**ON-SITE SEWAGE DISPOSAL SYSTEM
 HOWARD COUNTY HEALTH DEPARTMENT
 BUREAU OF ENVIRONMENTAL HEALTH**

SUBDIVISION: Brantwood II LOT NUMBER: 12

SEWAGE SYSTEM DESIGN DATA / LOT 12:

BRANTWOOD 2/1 Lot 12
 No Co HEALTH 11-27-00
 ATTN: MARK RIFKIN
 PLEASE REVIEW the
 septic area modification
 for approval. The remain-
 ing area is still over the
 10,000 ft required. Please
 call with your decision
 Thank you

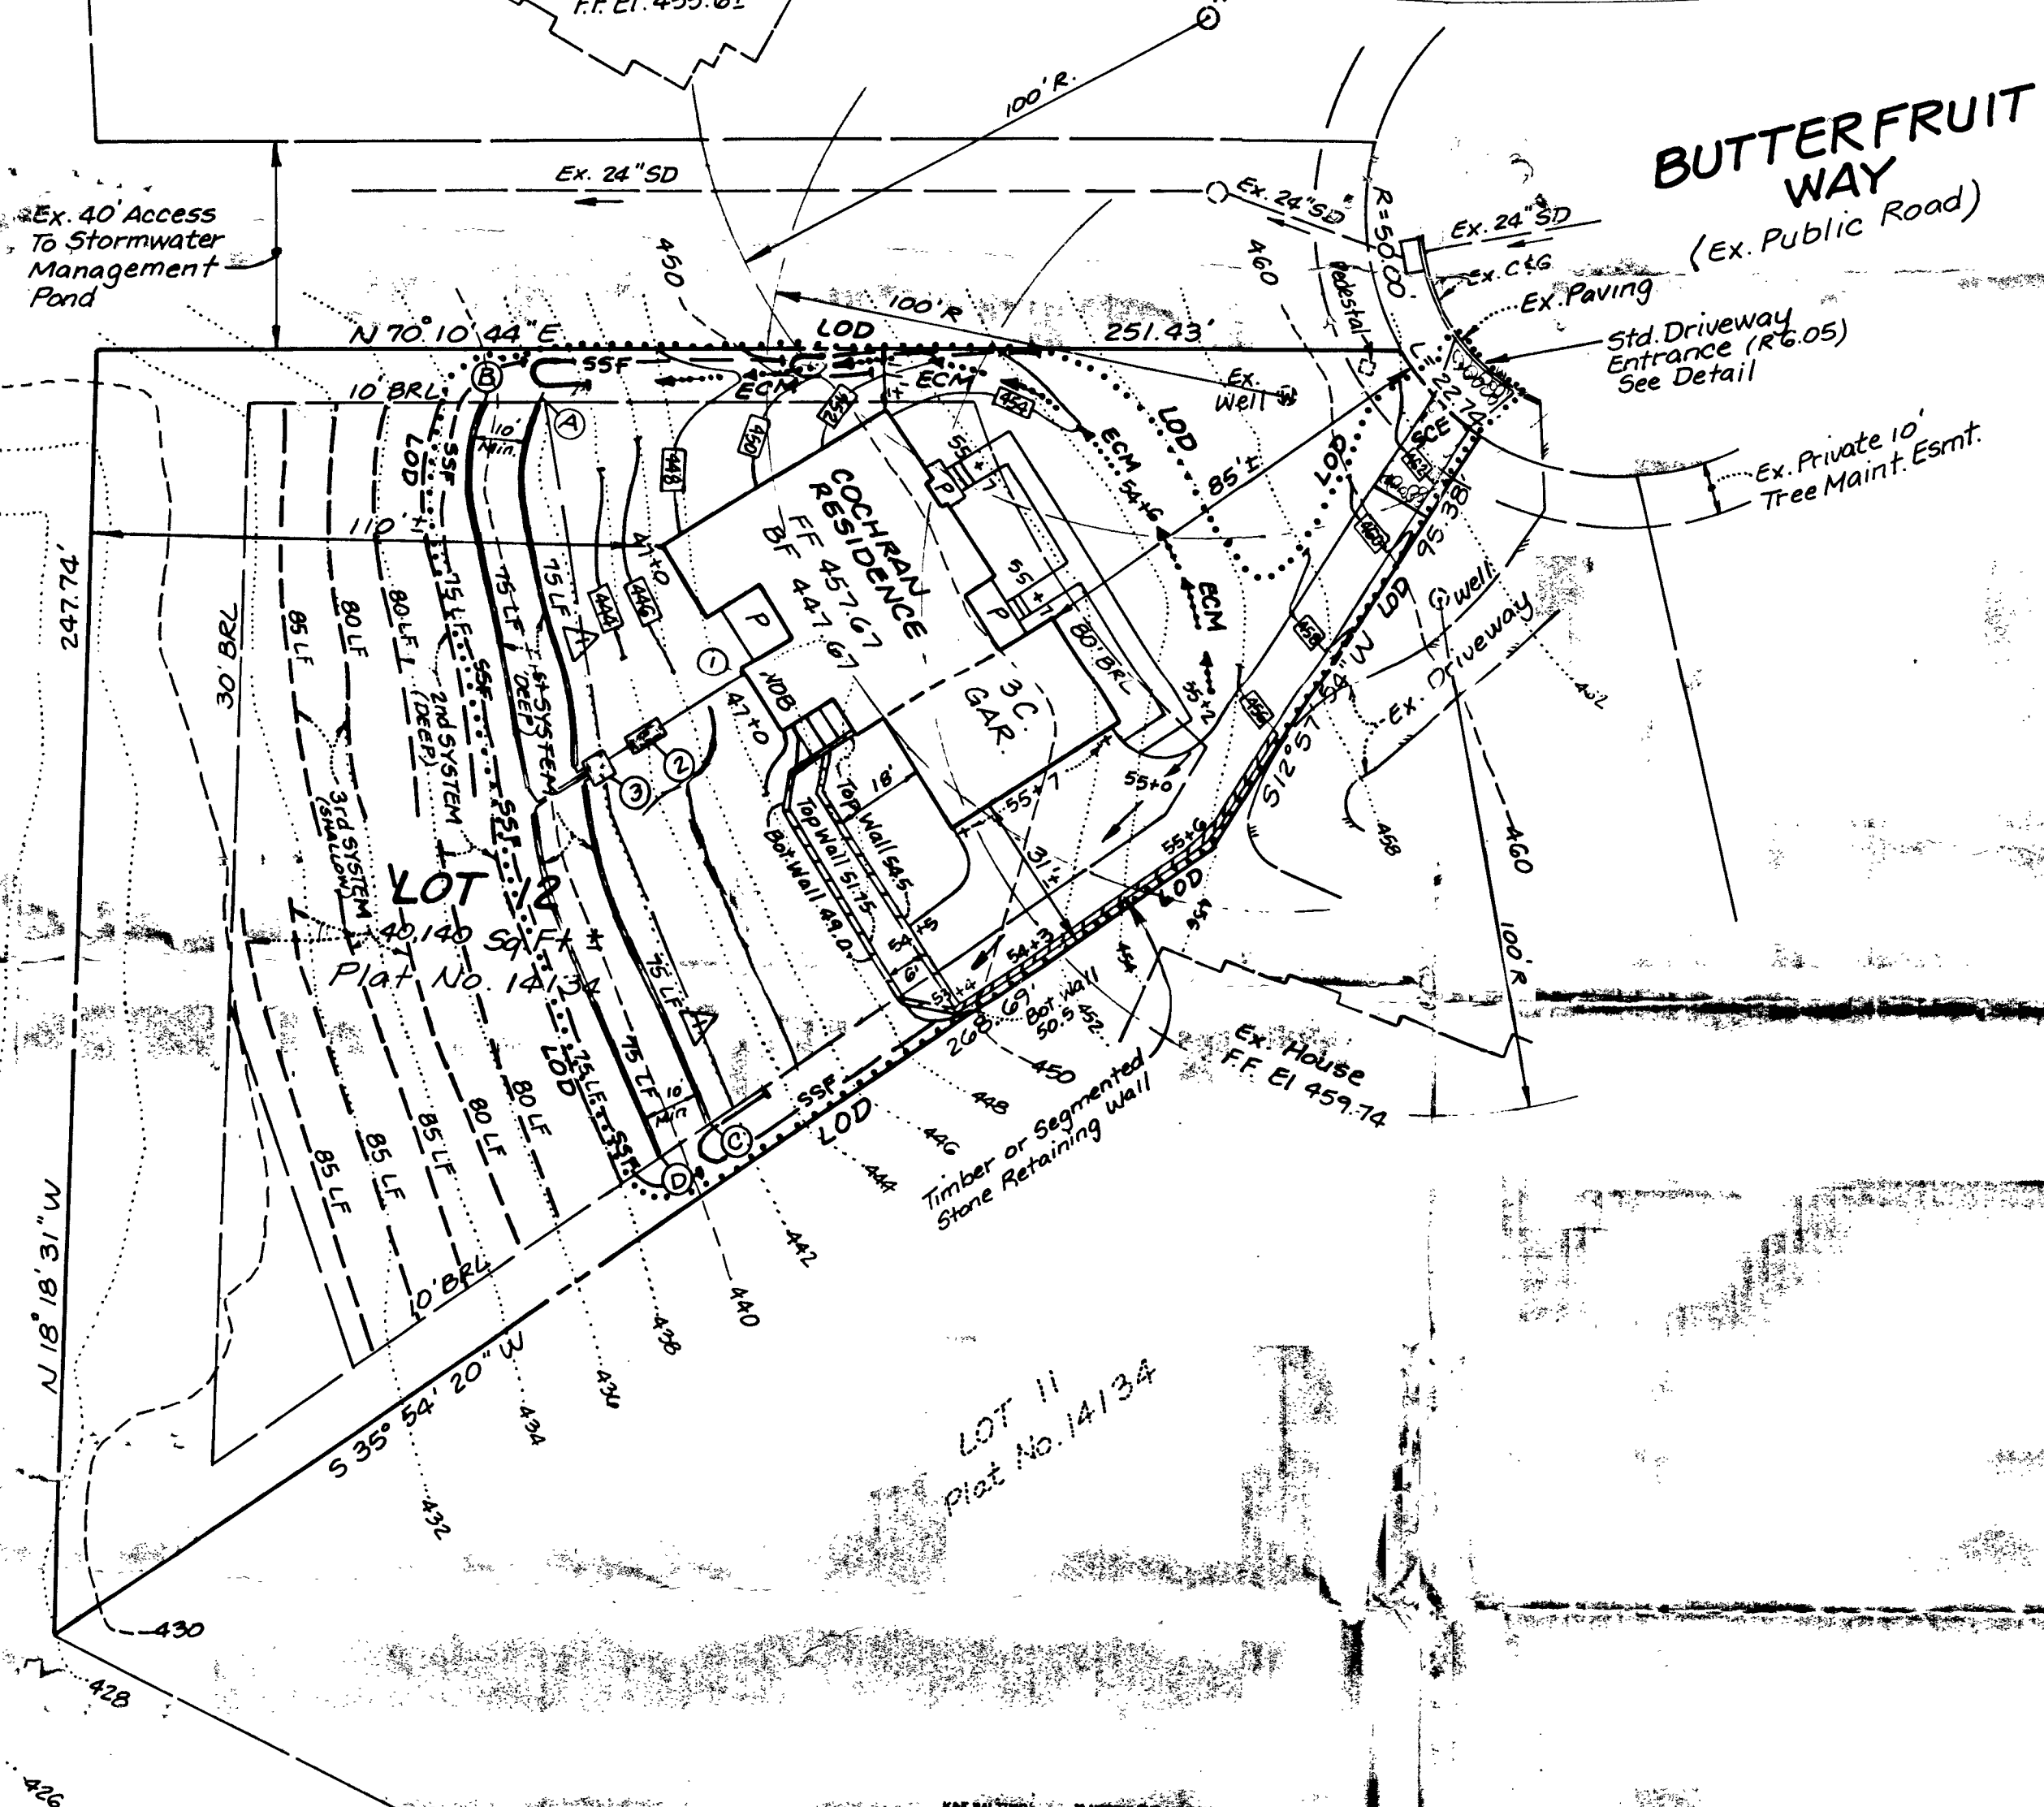
PRE-CONSTRUCTION T.C. discussion re trench field - system before House because of probable rock in initial Dptic Area, 6/27/02

6/27/02 Areas of 750% partially decayed mica fragments in the end of trench 1. Poured water into bottom of trench 1 in mica fragments. Second pour was ~ 1 minute per inch and slowed considerably from first pour ~ 30 sec. Will accept mica content since decayed rock does offer some treatment and pore rates would probably be above 2 minutes after some saturation. (BB) 6/28/02 O.K. to cover trenches and distribution box. (BB) 7/9/02 Test S.T. OK to cover tank (SC) 8/19/02 Spoke to Tom Prefers 22' bends Must have 10' of 2% slope into septic tank. 8/20/02

8/22/02 Cont. replumbed to S.T. OK to cover (S)

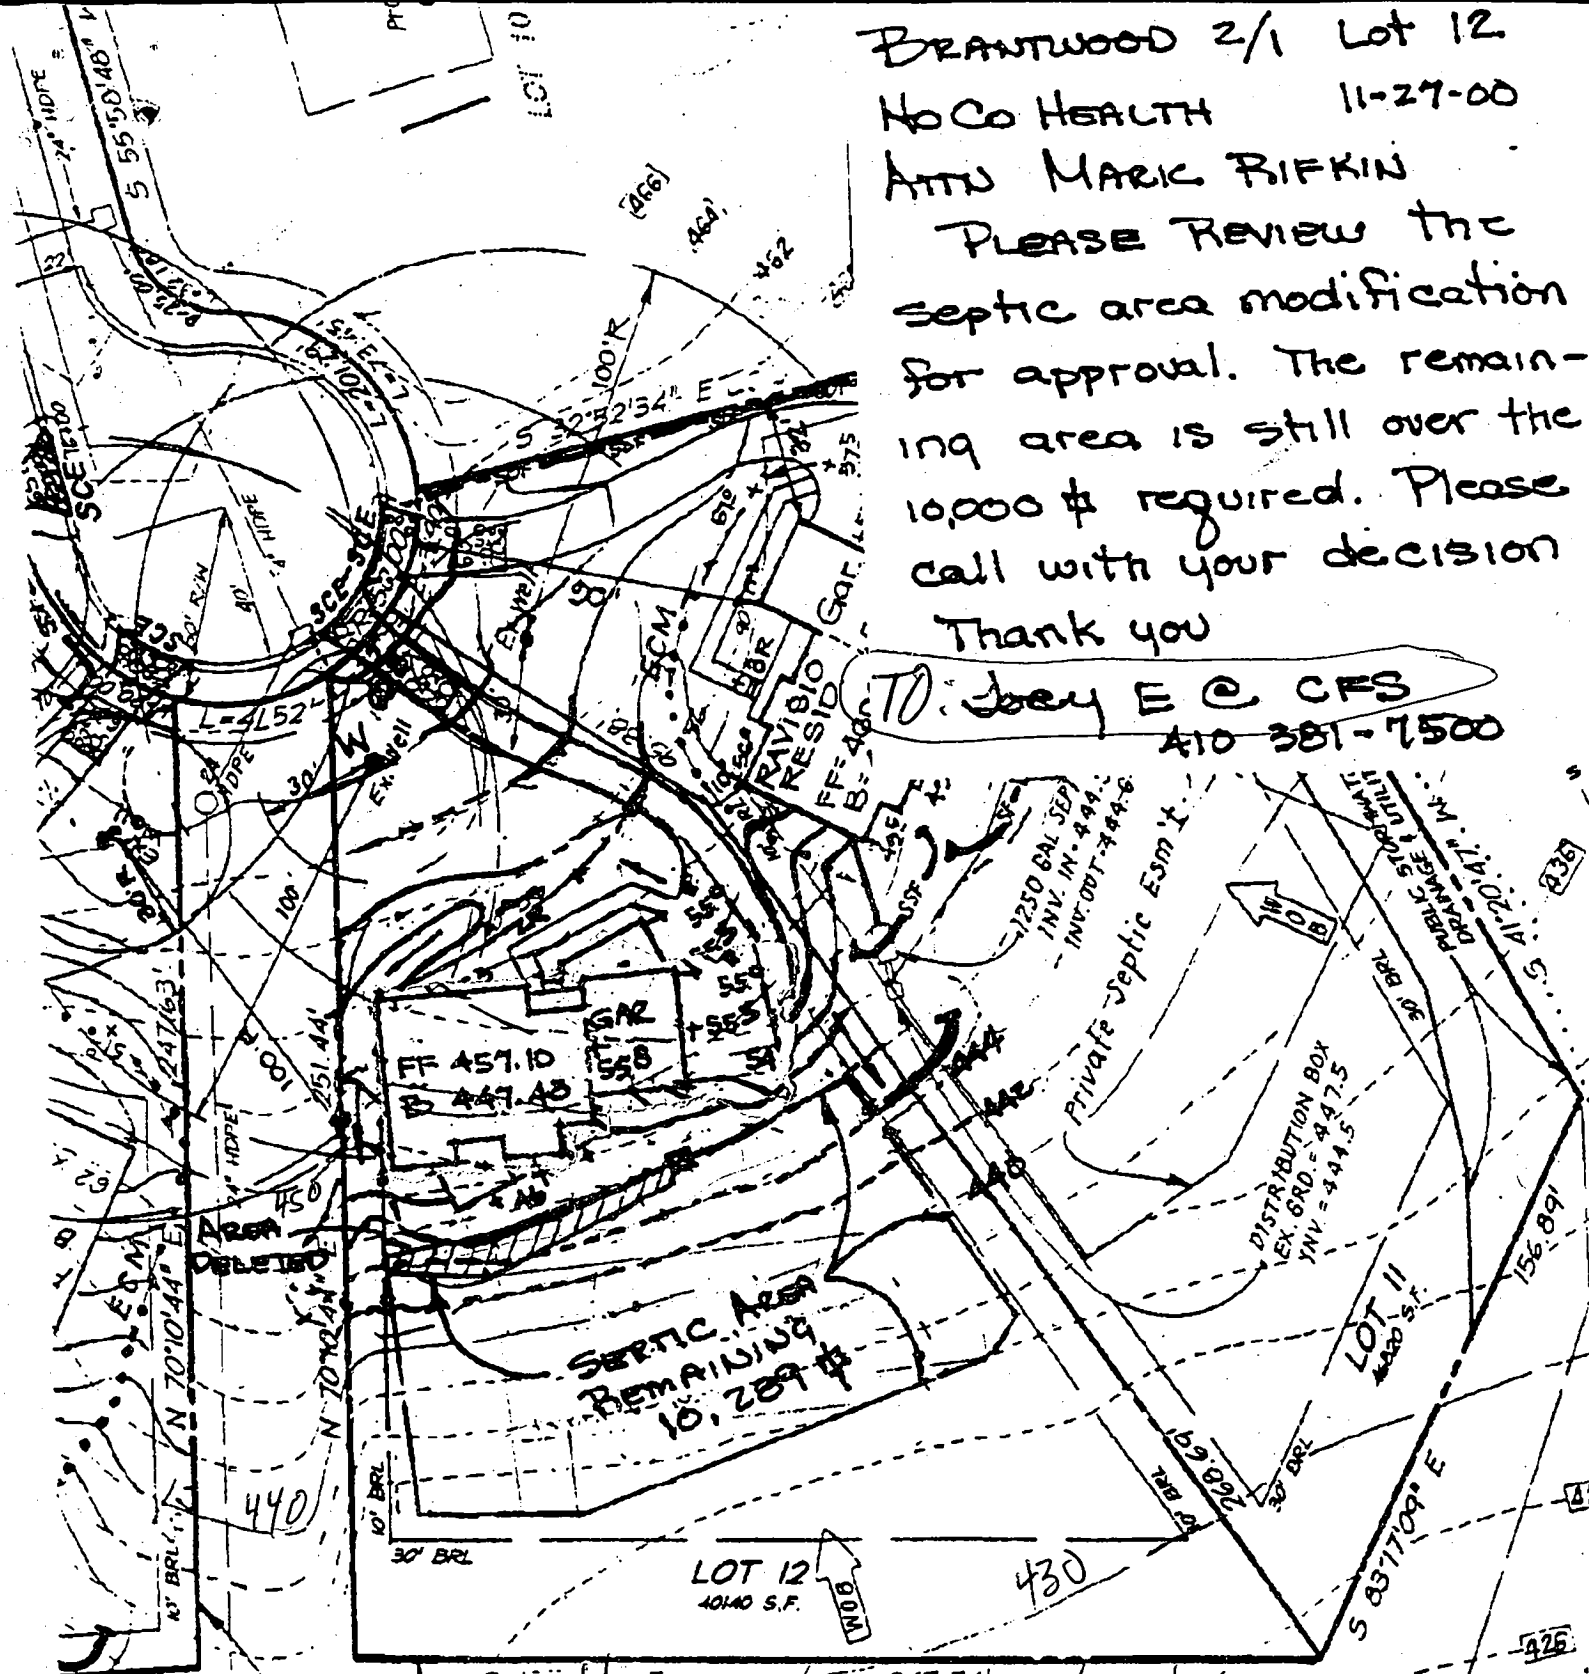
ORIGINAL AREA 10,849 ft²
 AREA DELETED 560 ft²
 AREA REMAIN. 10,289 ft²

ABOVE IS ATTACHED AND SUGGESTED HOUSE LOC WHICH ELIMINATES SRA ADJUSTMENT (MA)
 (faxed to Jo Eckert 12/8/00)

12/8/00 E T/c w/ Joan Cochran, buyer's mother: proposed adjustment is problematic because:
 a. 3x300' = 900' trench req'd to fit, and it is doubtful w/ adjustment + tight, even w/ adjustment
 b. 30% graded slope @ garage over SRA
 c. would not support buyer's desired deck (unspecific)
 d. area remains in front to slide house forward
 NO POSSIBLE way to approve downhill adjustment
 --- PUMPING SUGGESTED ---

BRANTWOOD 2/1 LOT 11-27-00

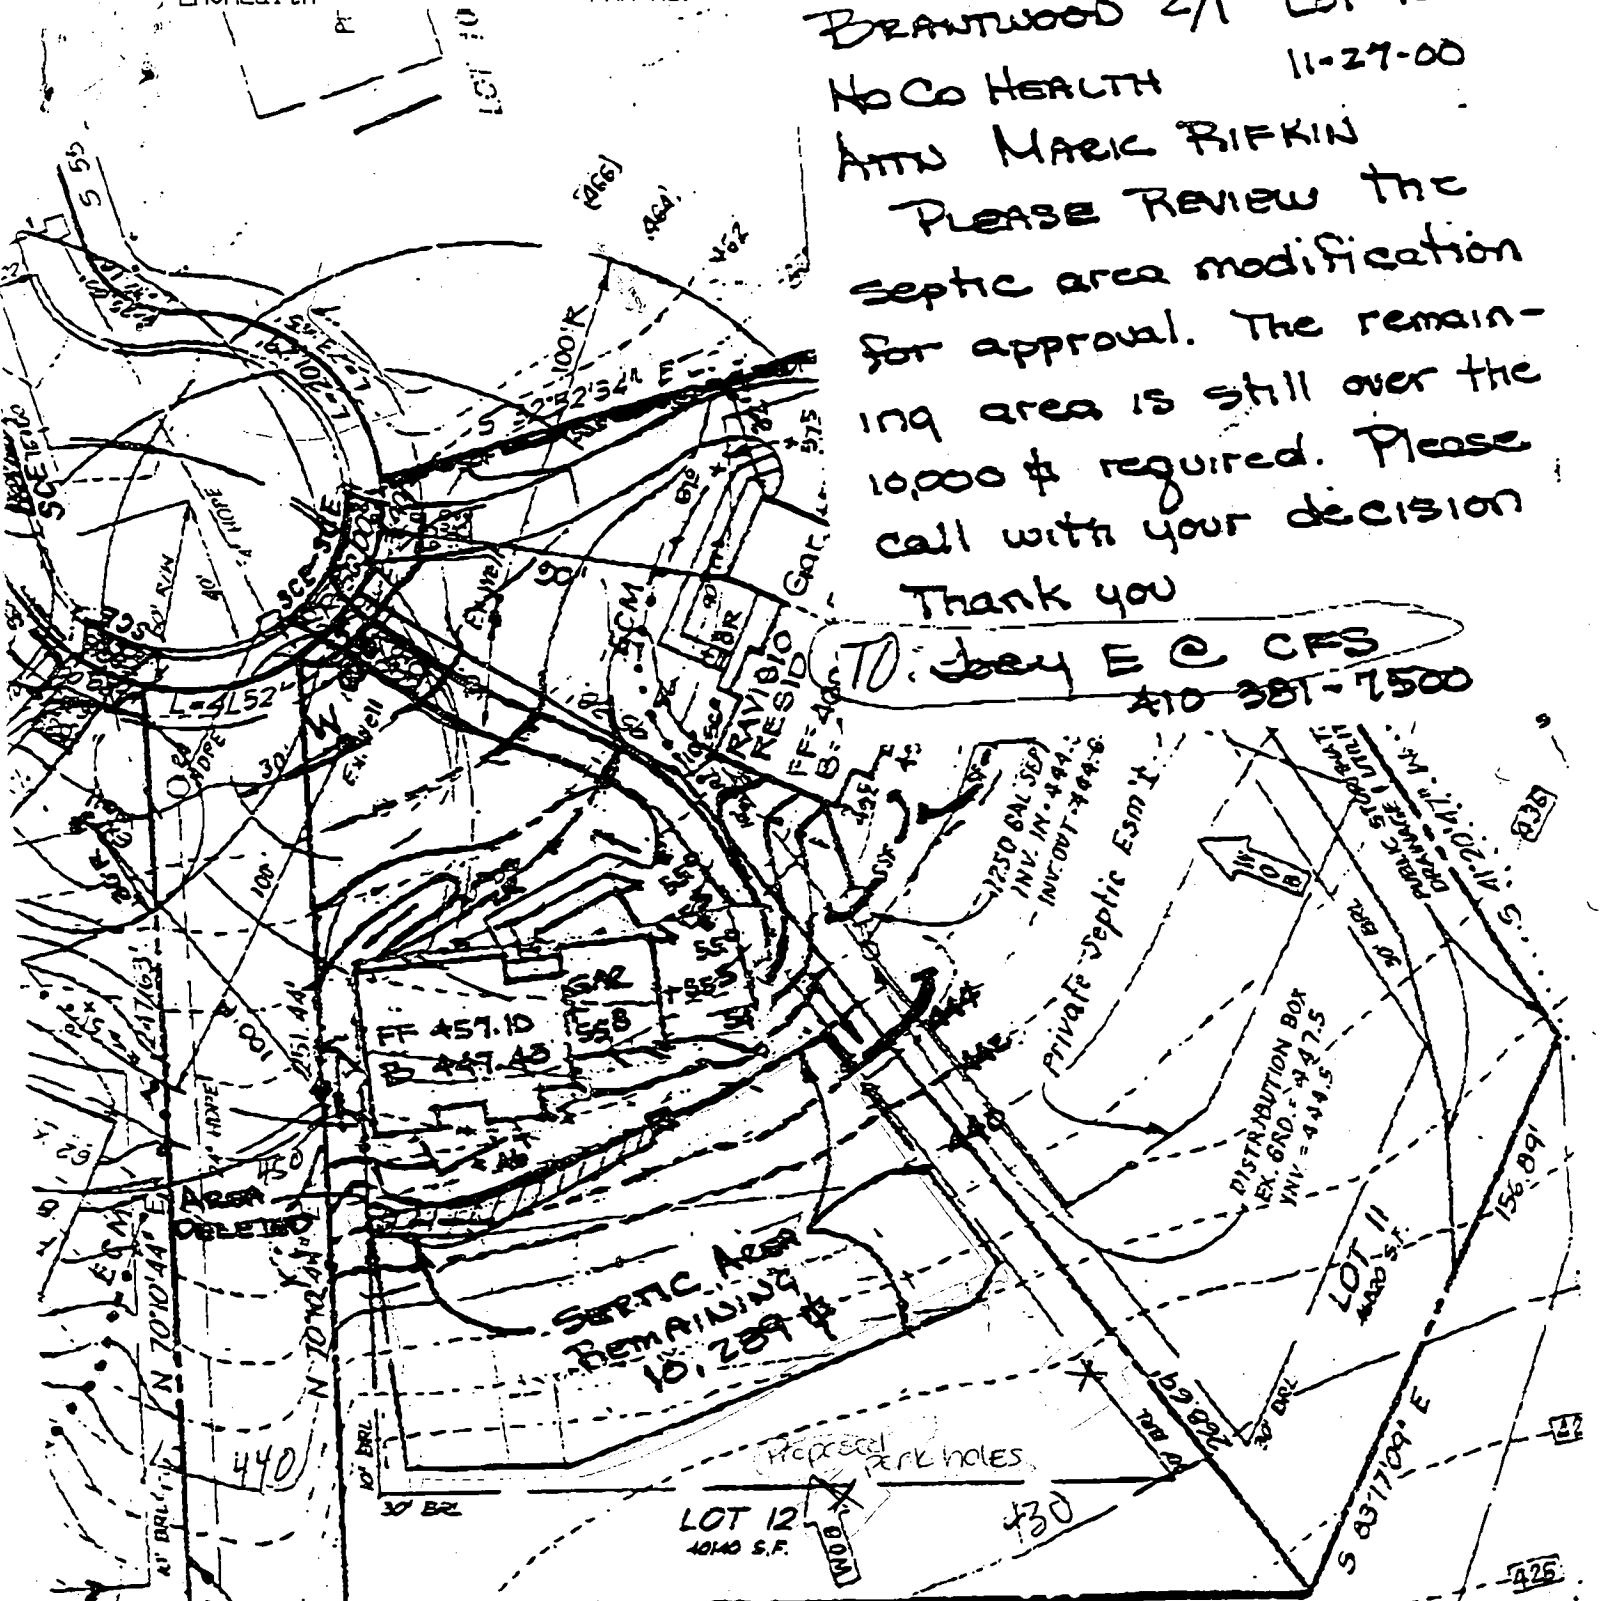
PLEASE REVIEW THE SEPTIC AREA MODIFICATION FOR APPROVAL. THE REMAINING AREA IS STILL OVER THE 10,000 \$ REQUIRED. PLEASE CALL WITH YOUR DECISION
Thank you

ORIGINAL AREA 10,849 \$

AREA DELETED 560 \$

AREA REMAIN. 10,289 \$

30' BUFFER ATTACHED AS SUGGESTED HOUSE LOC WHICH ELIMINATES SRA ADJUSTMENT

12/3/00 E
 247.74' buyer's
 w/ Joan Cochran, mother of for 5 Bk
 proposed adjustment is problematic because:
 a. 3x300' = 900' trench req'd to fit, and it is doubtful adjustment + tight, even w/ adjustment
 b. 30% graded slope @ garage over SRA
 c. would not support buyer's desired deck (unspecif.)
 d. area remains in front to slide house forward
 NO POSSIBLE way to approve downhill adjustment
